Illinois Pollution Control Board
R2014-10

**FINAL REPORT
ROUND 10 DAM ASSESSMENT
DYNEGY MIDWEST GENERATION, LLC – BALDWIN ENERGY COMPLEX
PRIMARY FLY ASH POND, SECONDARY FLY ASH POND, SECONDARY POND,
INTERMEDIATE POND, FINAL POND
BALDWIN, ILLINOIS**

RE: FINAL Assessment of Dam Safety of Coal Combustion Surface Impoundments at the Baldwin Energy Complex

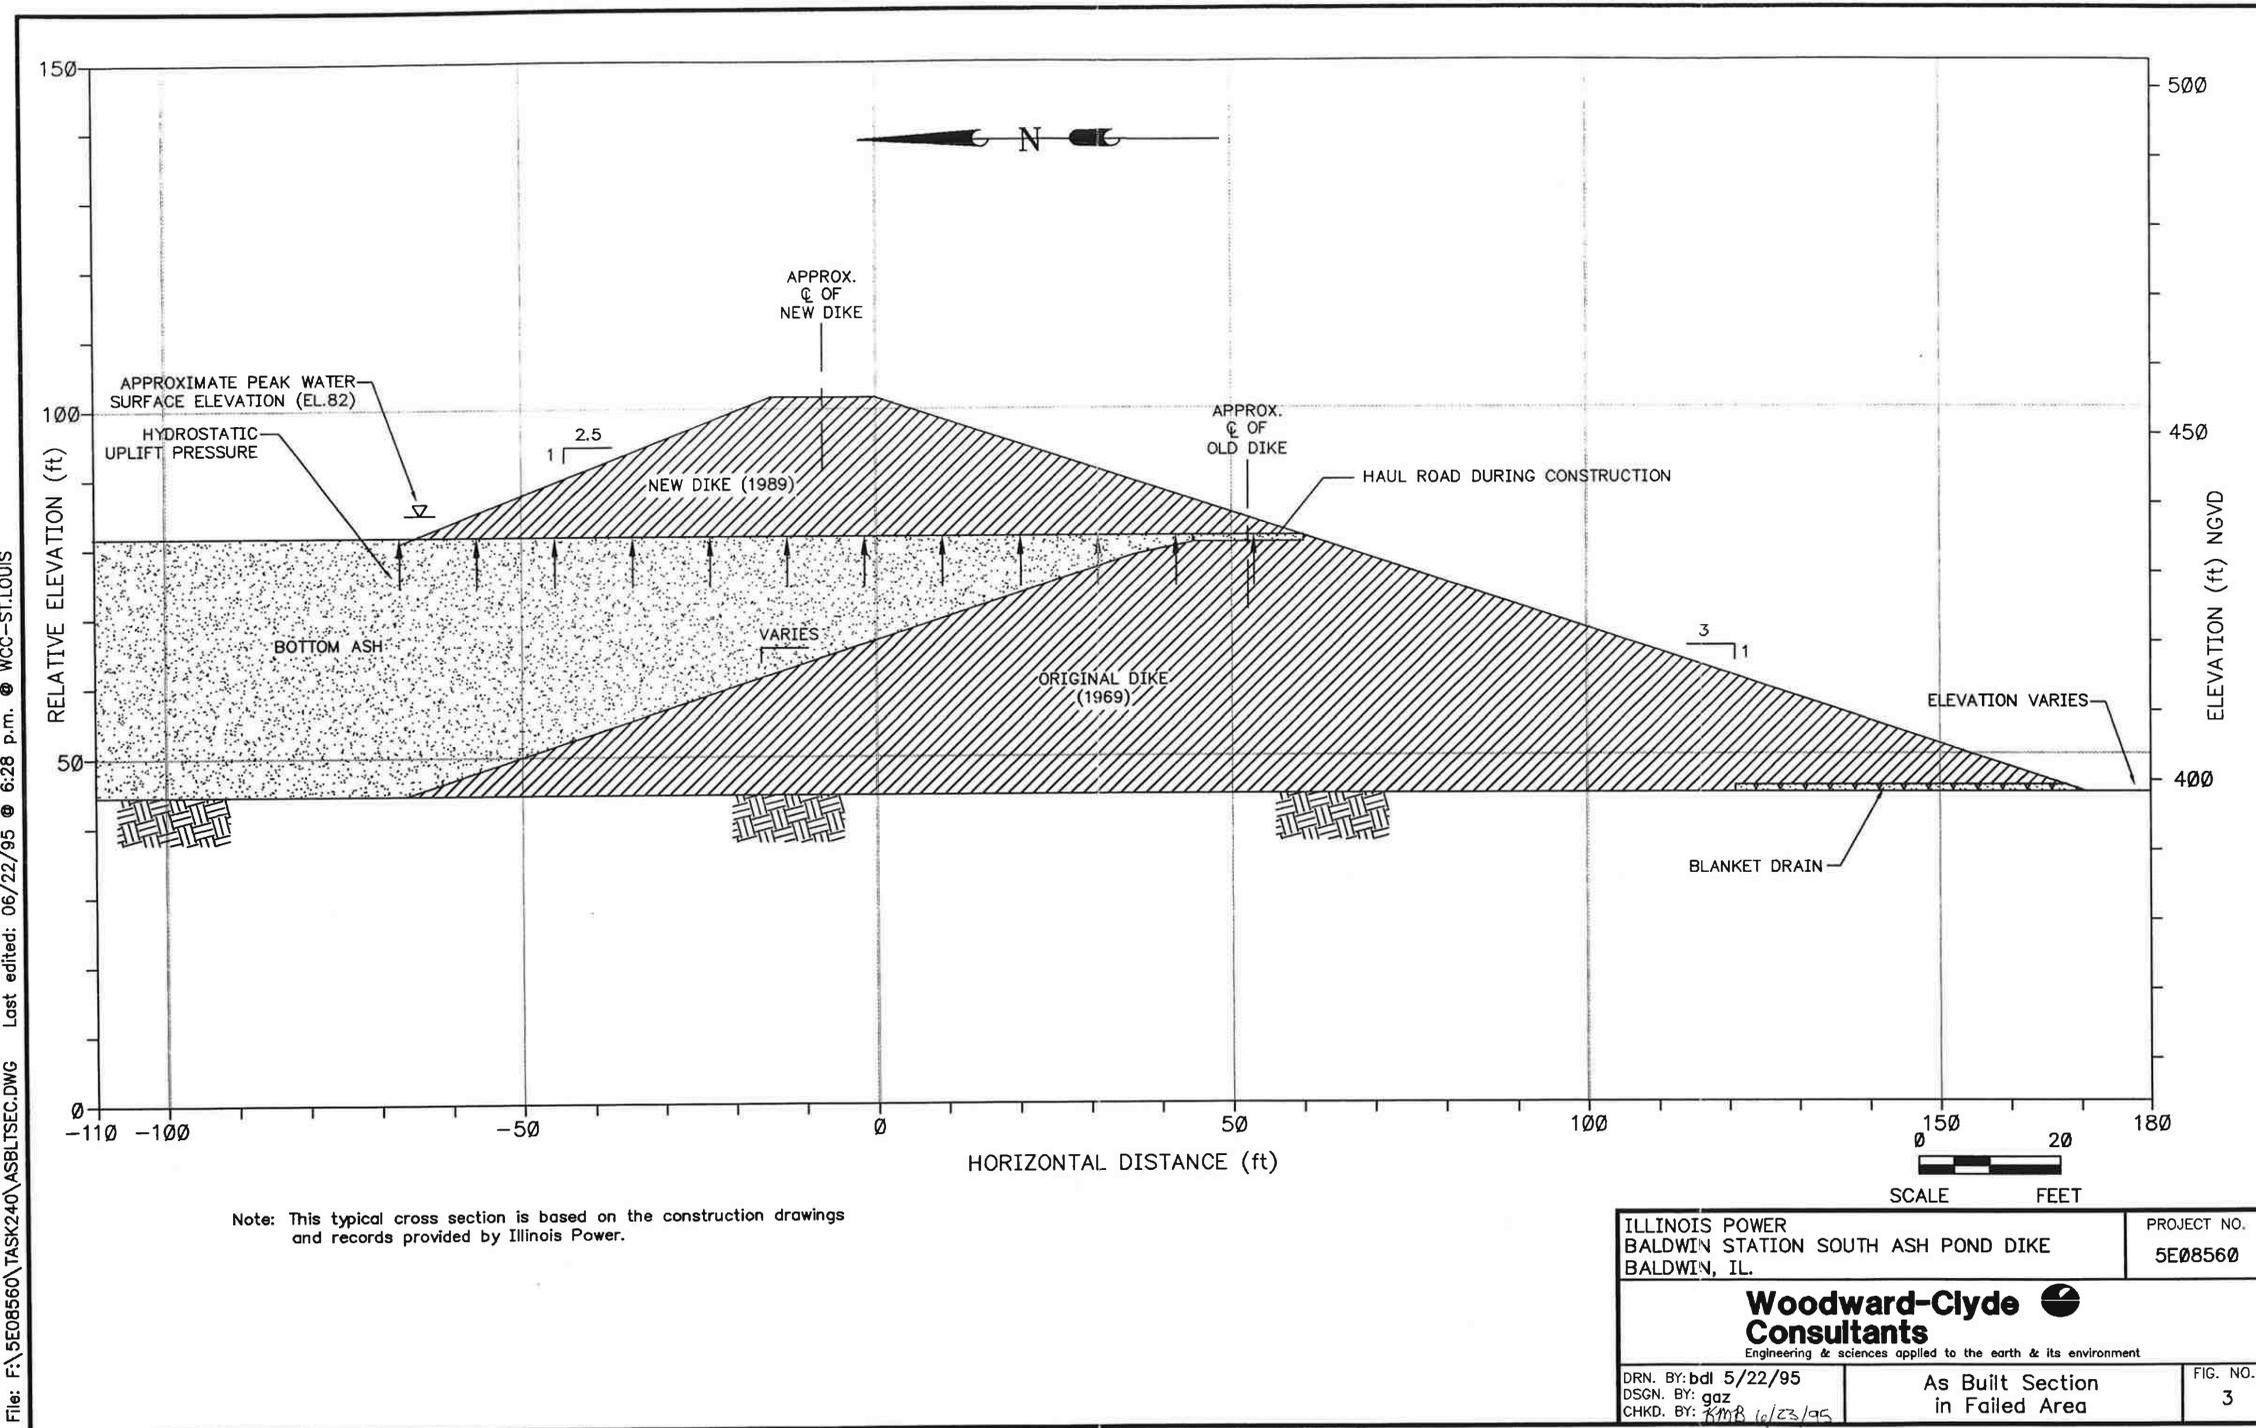
A typical design cross section of the 1969 southern embankment of the PFAP is shown in **Figure 4**. The 'as built' cross section of the embankments after the 1989 raise, as recreated by Woodward Clyde and documented in the Failure Analysis, is provided as **Figure 5**. Based on the upstream construction shown on Figure 5, the 1989 raise was partially constructed over wet CCW.

BALDWIN ENERGY COMPLEX
10901 BALDWIN ROAD
BALDWIN, ILLINOIS
TYPICAL CROSS SECTIONS
THROUGH INTERMEDIATE EMBANKMENT
JOB NO. 01.0170142.30
FIGURE NO. 7

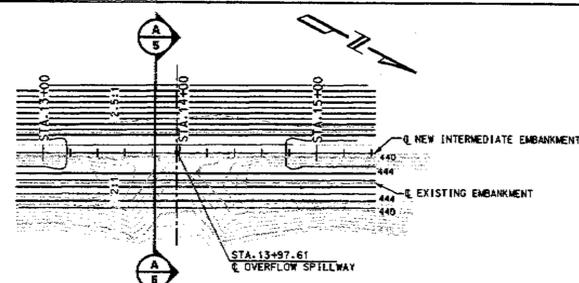
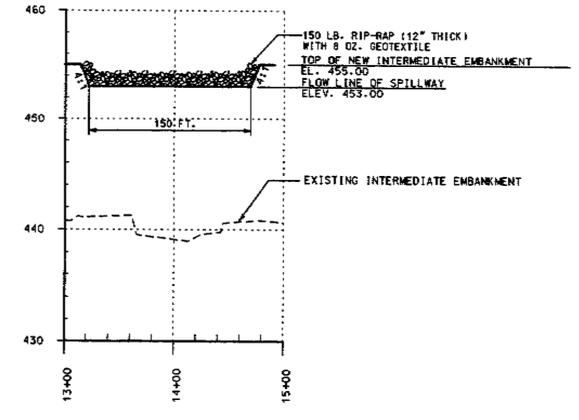
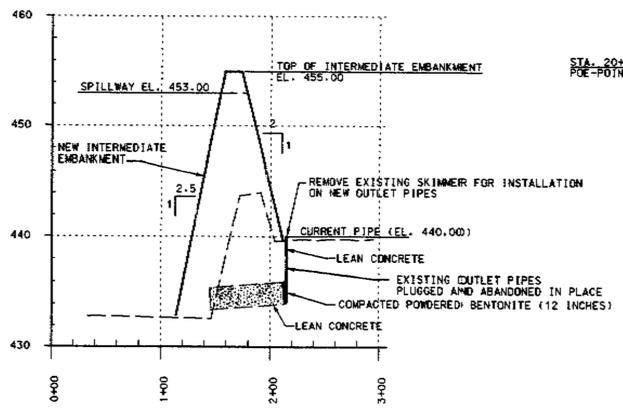
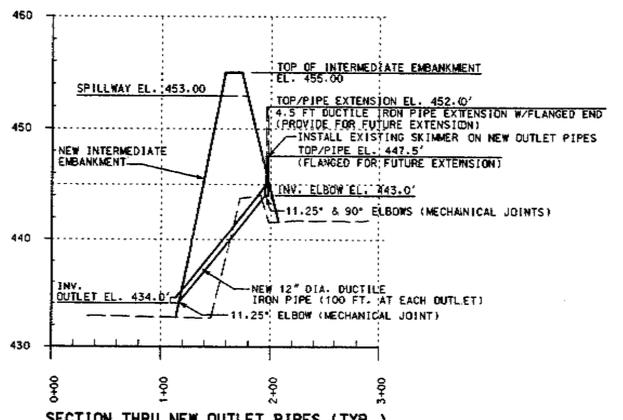
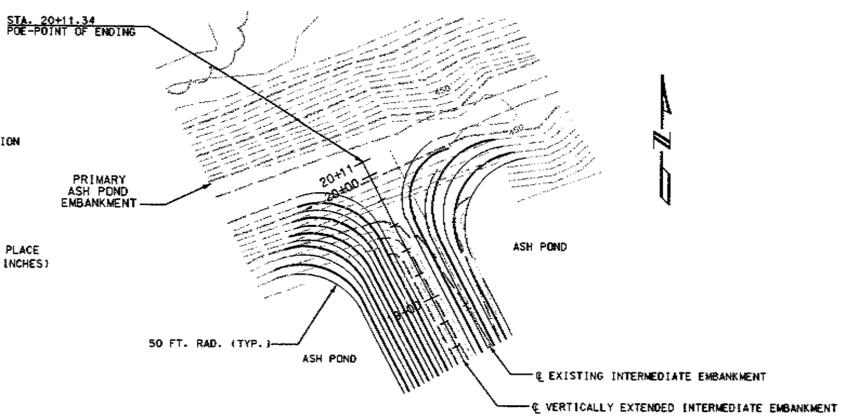
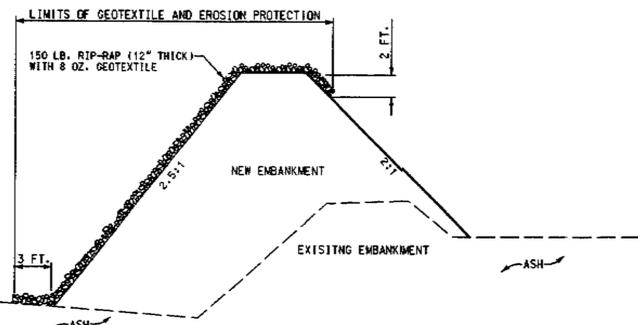
An overflow spillway that is approximately 2 feet deep and 200 feet wide with an invert elevation of 455 feet MLS was constructed in the Intermediate Embankment. The spillway and downstream slope was lined with 12-inch riprap. The water elevation in the southern portion of the PFAP is controlled using five (5) decant pipes that were 12-inches in diameter without trash racks or stop logs. The typical cross sections and decant pipes through the Intermediate Embankment are provided on **Figure 7**.

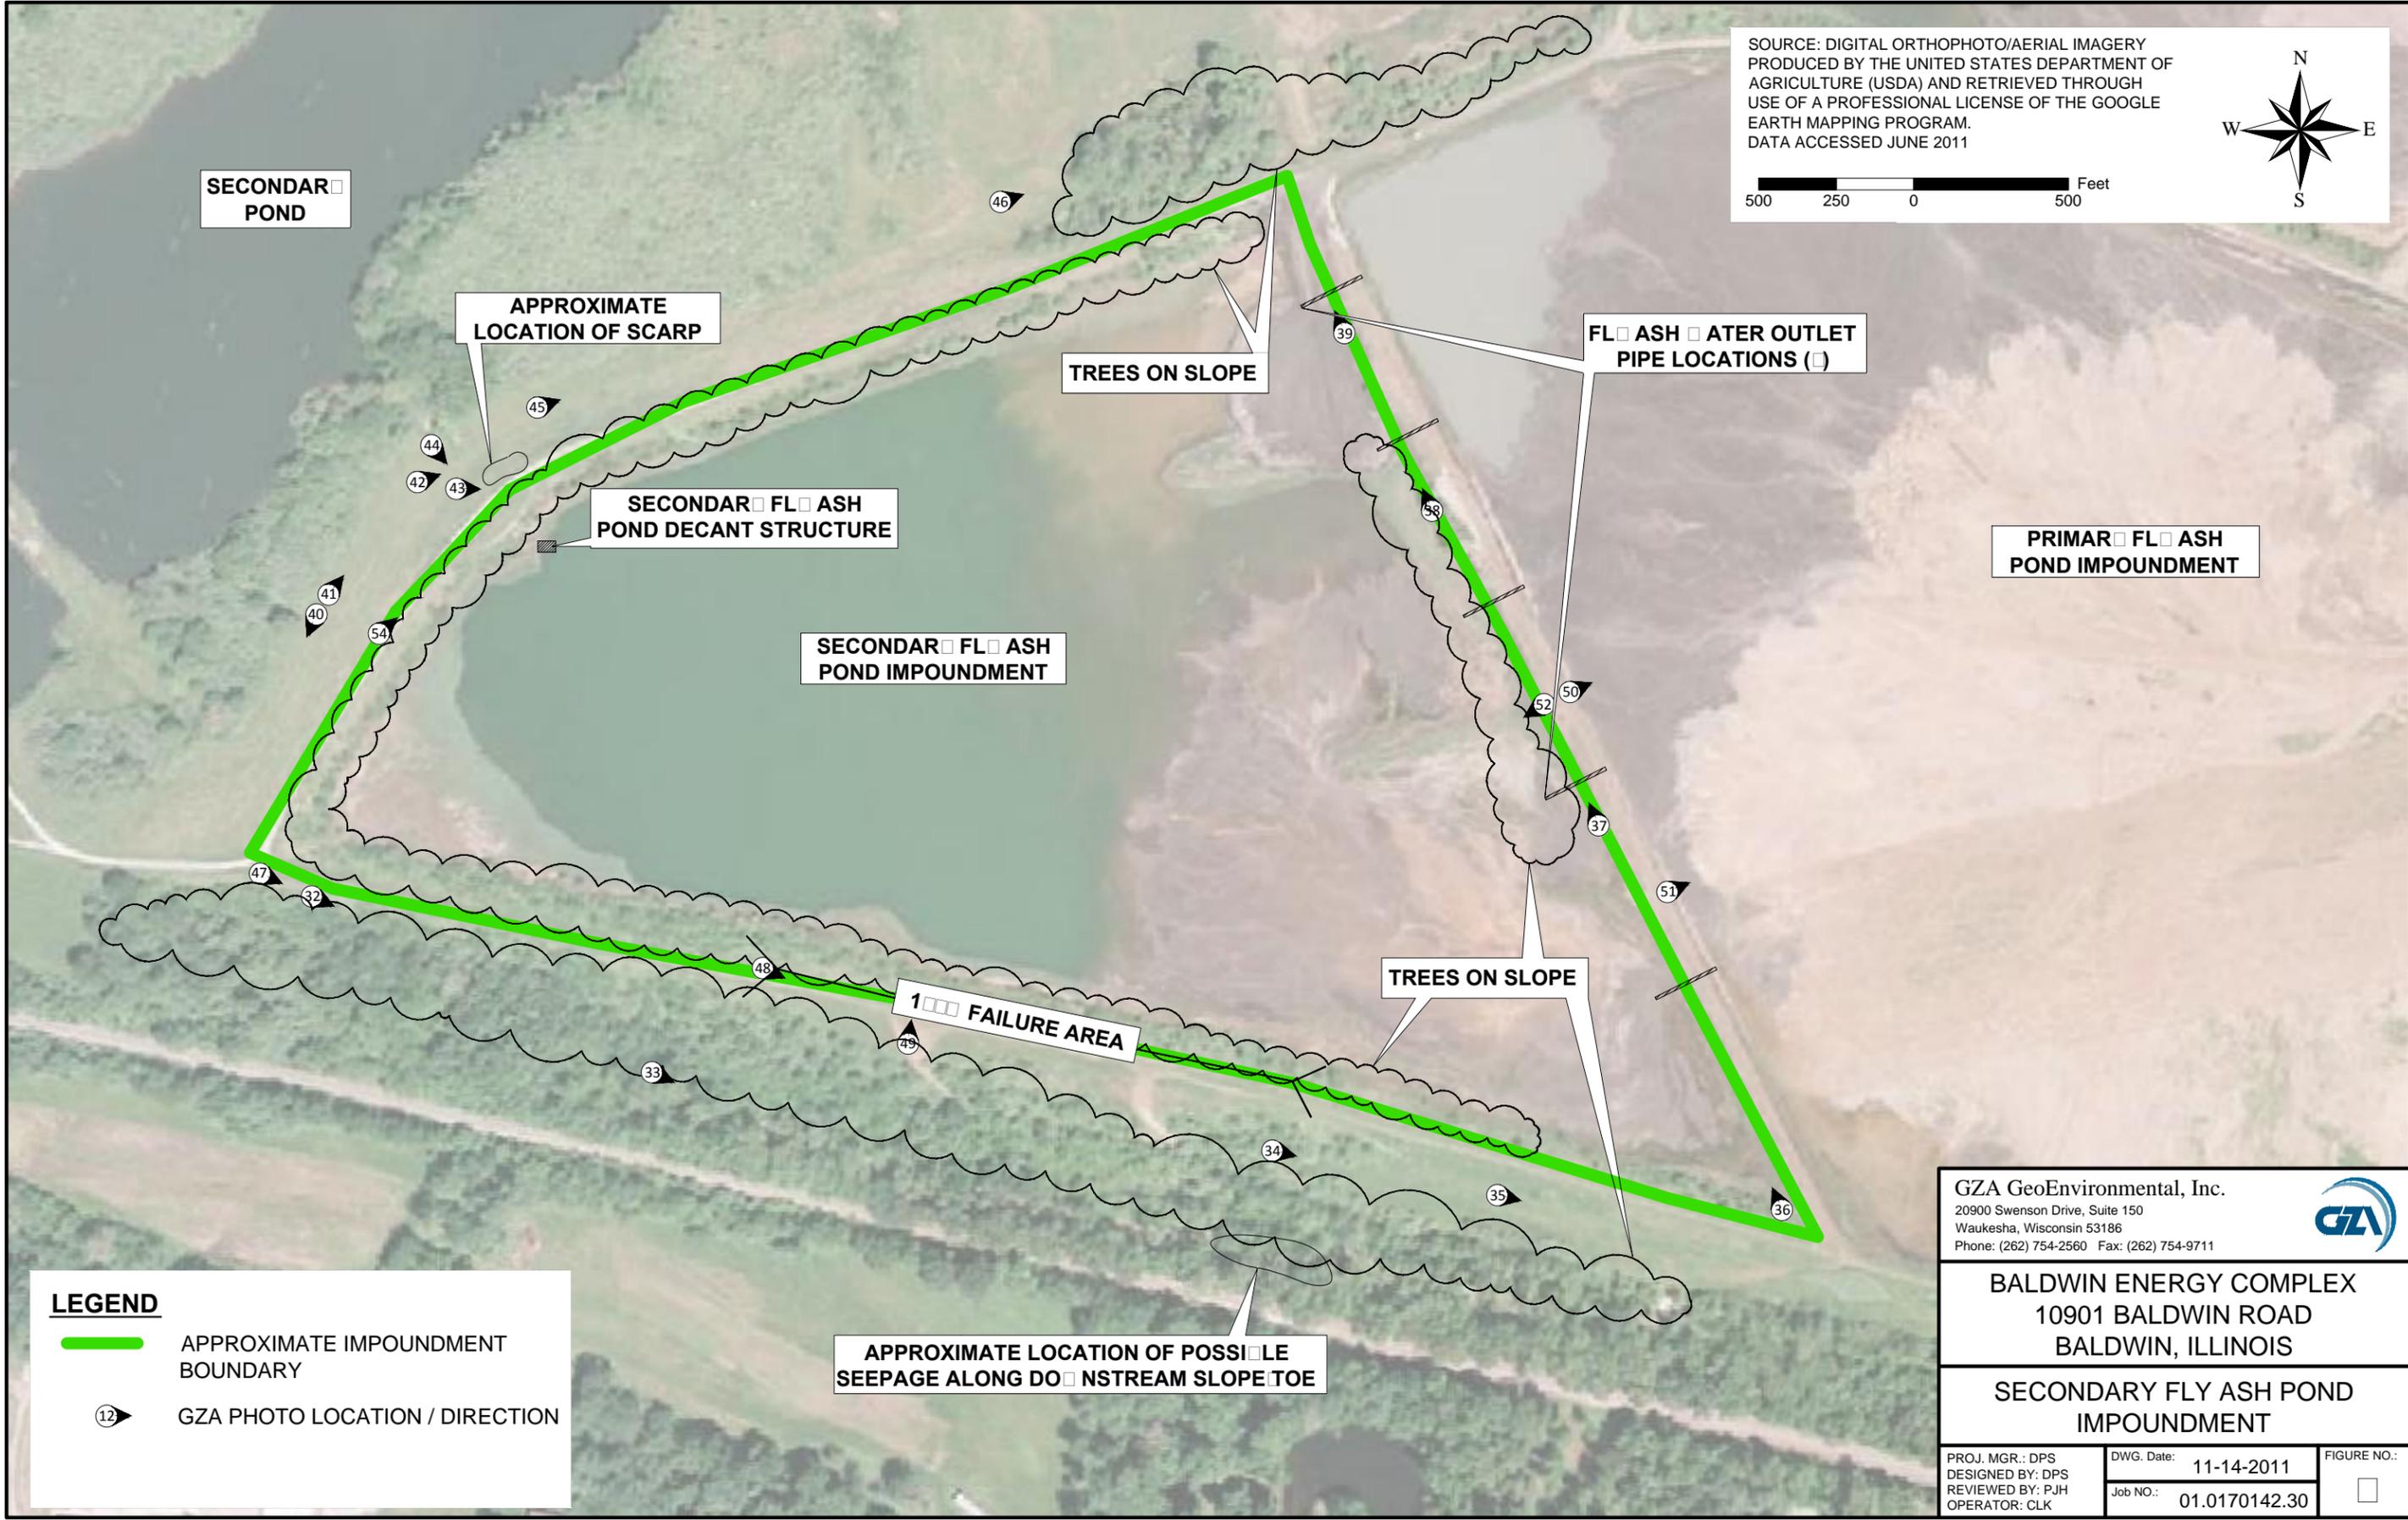
A scarp was observed near the crest of the downstream slope of the northwestern embankment at the approximate location shown on **Figure 8**. The scarp was approximately 100 feet wide along the slope and extended approximately 30 feet to 40 feet down the slope. The vertical face at the head of the scarp was approximately 2 feet high. The scarp had reportedly developed 2 weeks prior to our assessment and repair of the scarp has been completed since our visit according to BEC personnel. Moist surface conditions that may have been an indicator of seepage were observed along the toe of the southern embankment. However, we were not able to confirm the nature or extent of moist conditions due to the thick vegetation.

APPROXIMATE SCALE IN FEET	0 25 50
PROJ. MGR: DPS	DESIGNED BY: DPS
REVIEWED BY: PIJ	OPERATOR: CLK
DATE: 11-11-2011	
BALDWIN ENERGY COMPLEX 10901 BALDWIN ROAD BALDWIN, ILLINOIS	INSTRUMENTATION INSTALLED NEAR 1995 FAILURE AREA
JOB NO. 01.0170142.30	FIGURE NO. 9
REV. NO.	DESCRIPTION
BY	DATE

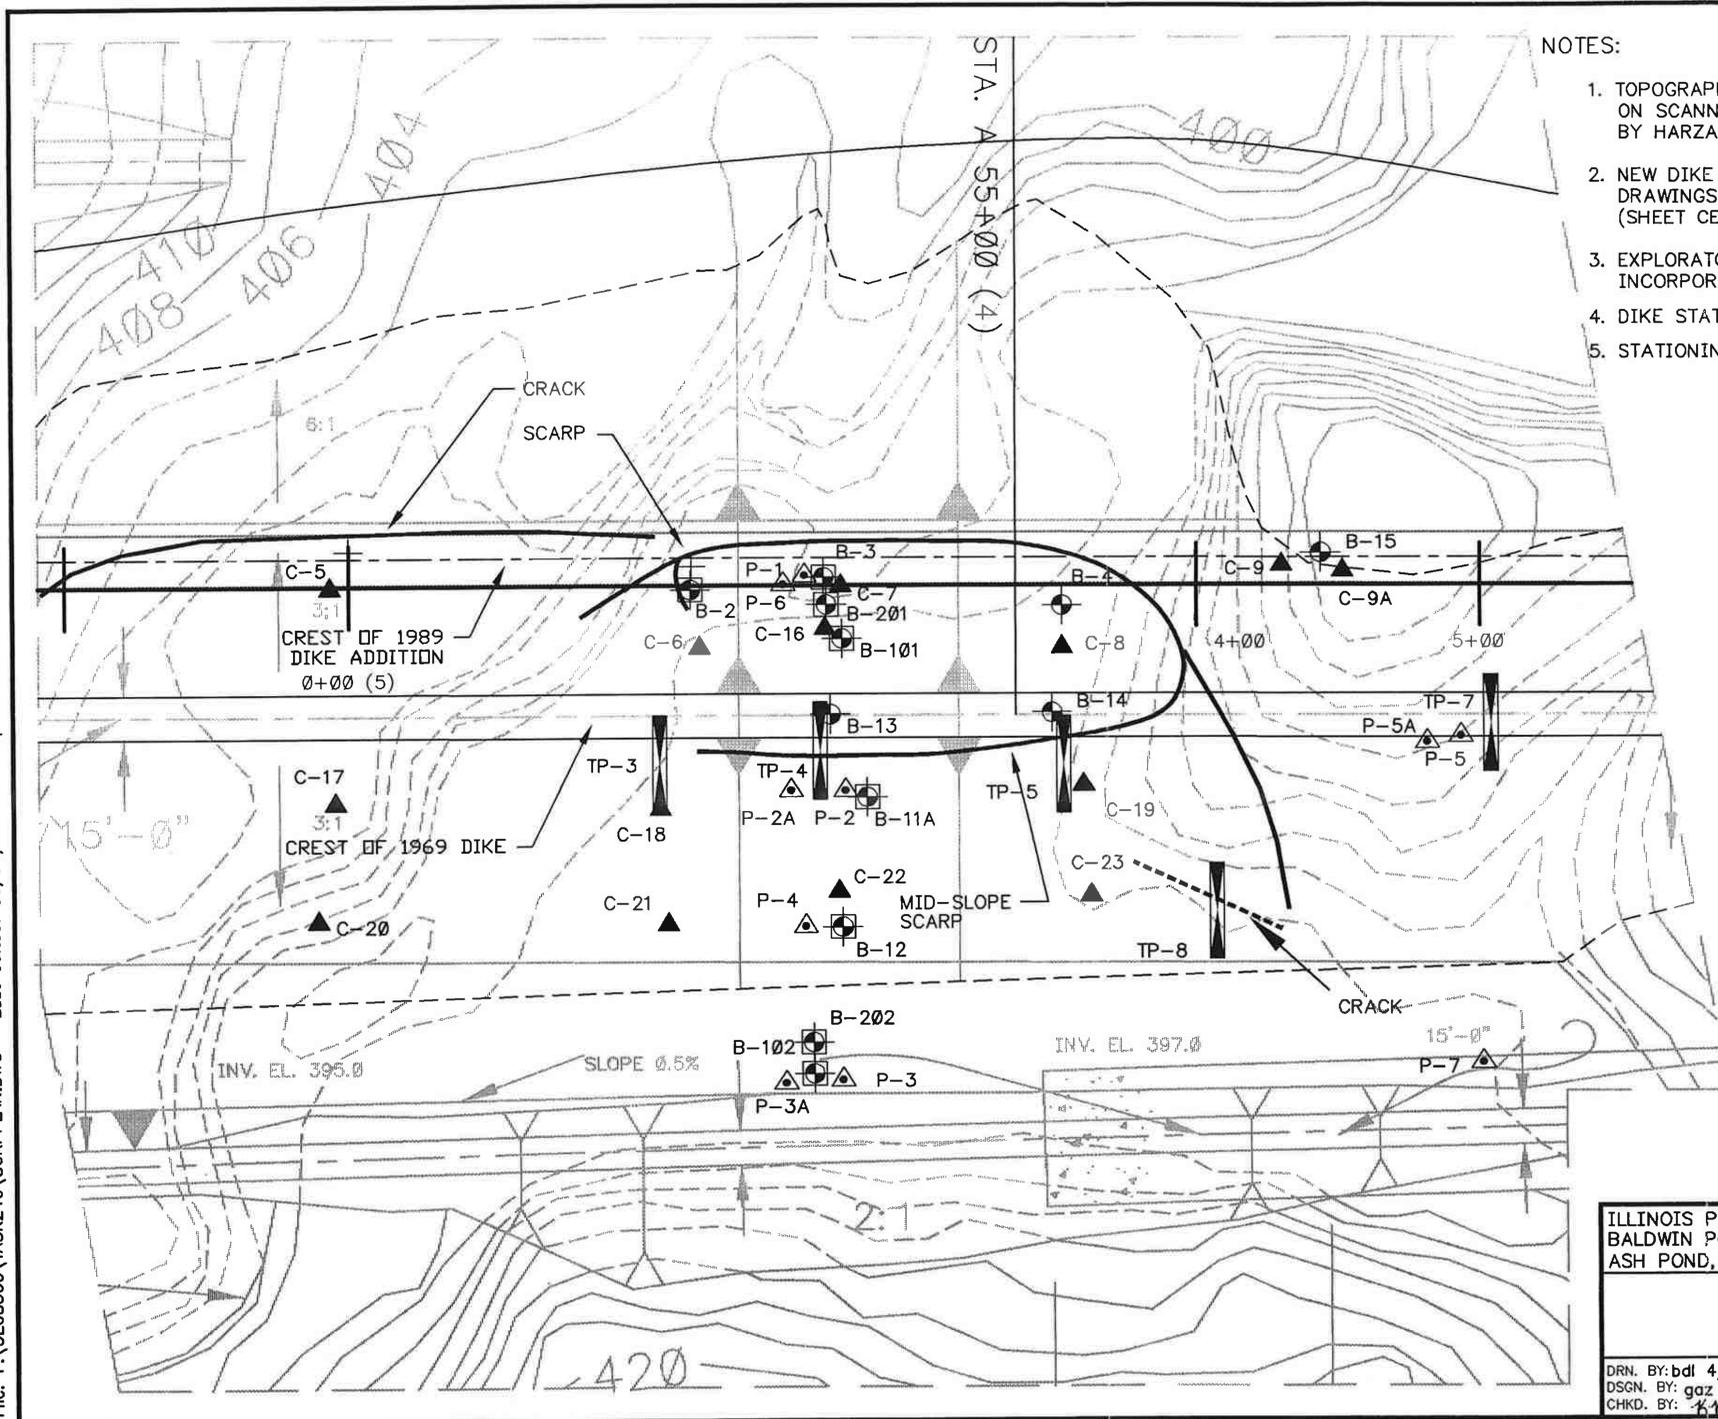
Instrumentation at the impoundment includes one well, nine vibrating wire piezometers, and four inclinometers in the area of the 1995 failure. The instrument locations are shown on **Figure 9**.
